Symbol Error Probabilities for Functional Interface Testing

Supporting Comment 2

IEEE P802.3dj

January, 2026 Austin, Texas

Expected time to one error:

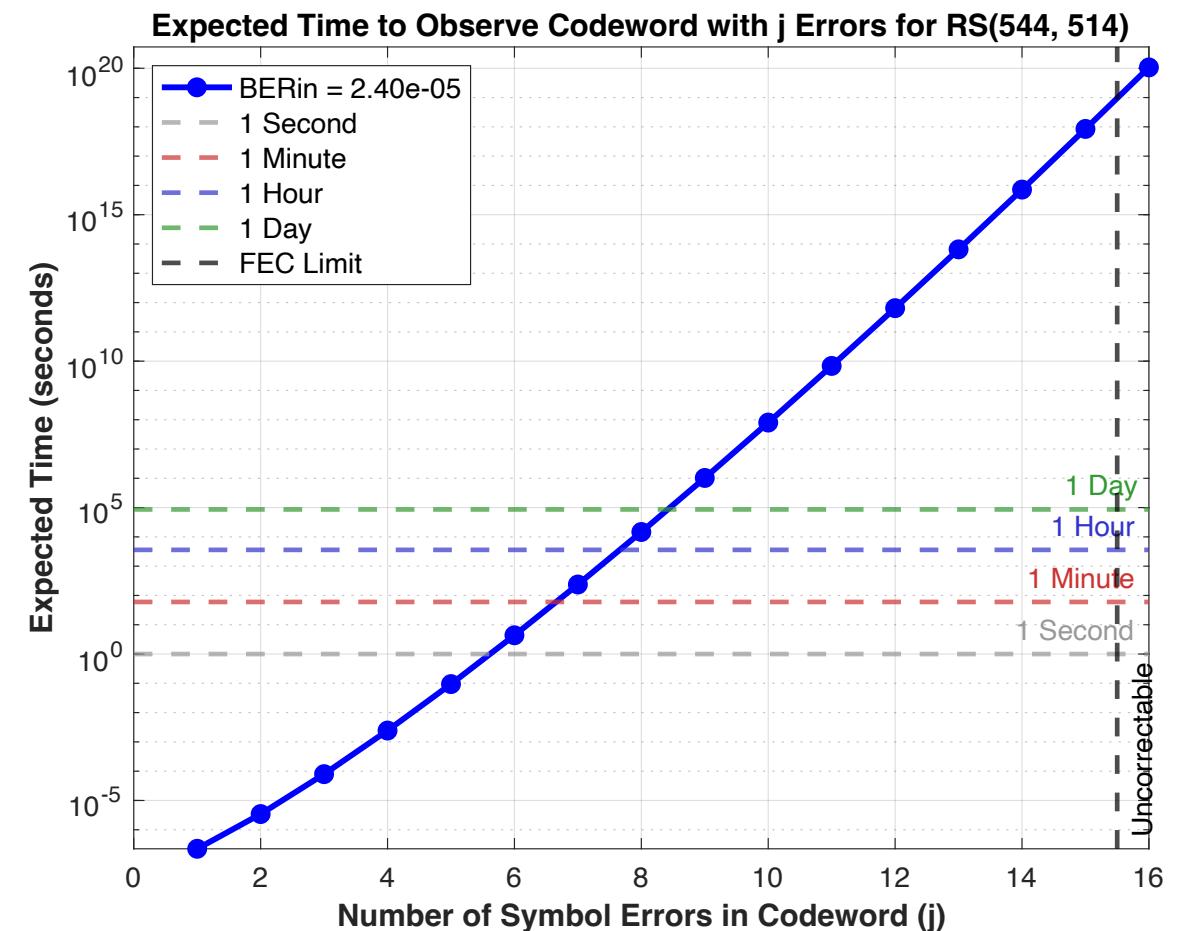
The chart shows the expected time to observe one codeword with $1 \leq j \leq 16$ symbol errors at 212Gb/s

For the Transmitter Functional Test, Symbol errors of ≥ 8 aren't required for reasonable test times.

- A 1 minute test time is being proposed for this test

Issues with current 802.3dj mask

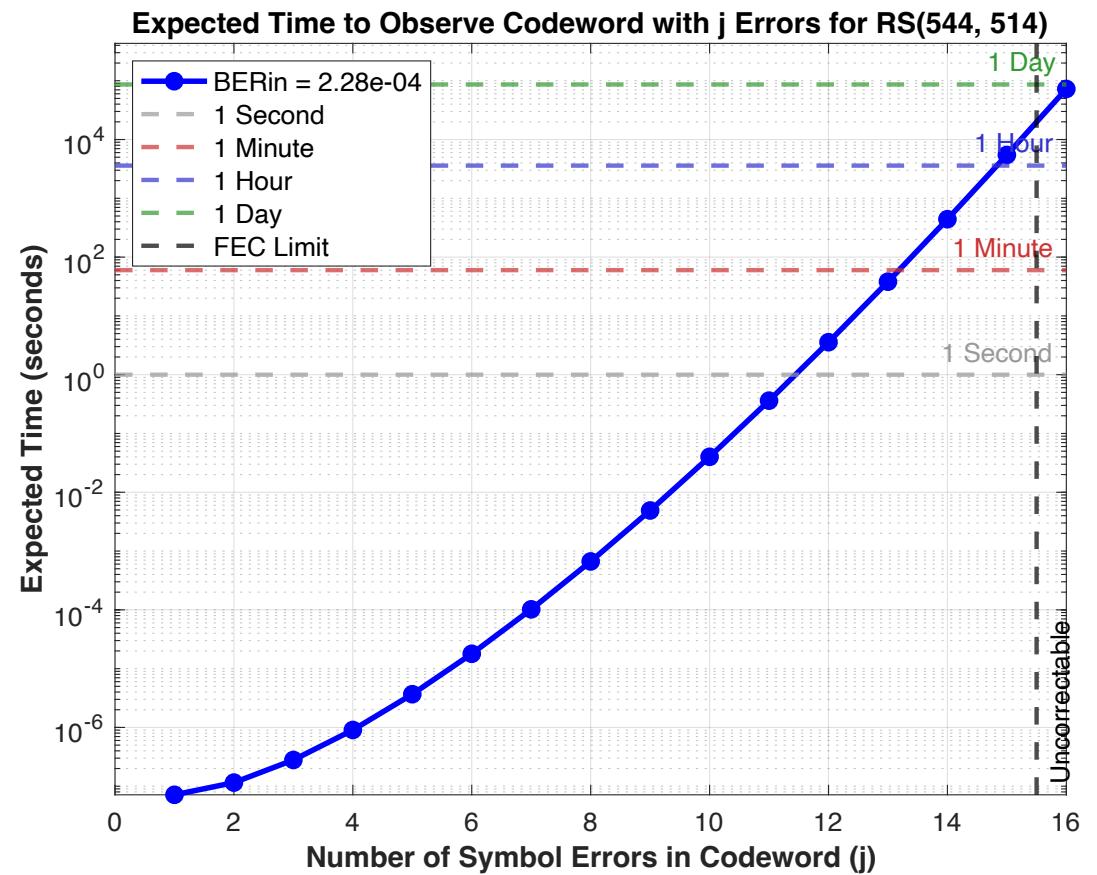
Symbol error bins 1-8 are defined based on a 2.4e-5 BER

Symbol error bins 9-16 are assigned the same probability as bin 16 for a BER of 2.28e-4

- The bins that result in uncorrectable codewords are defined in a way that allows higher counts

In a one-day soak, ~four 16 symbol-error (ie uncorrectable) codewords would pass the test.

Codewords with > 16 symbol errors have no limit applied

The flat symbol error mask in the current spec would potentially allow multiple uncorrectable codewords – requiring zero counts for higher symbol errors than would be expected based on the test time resolves this issue
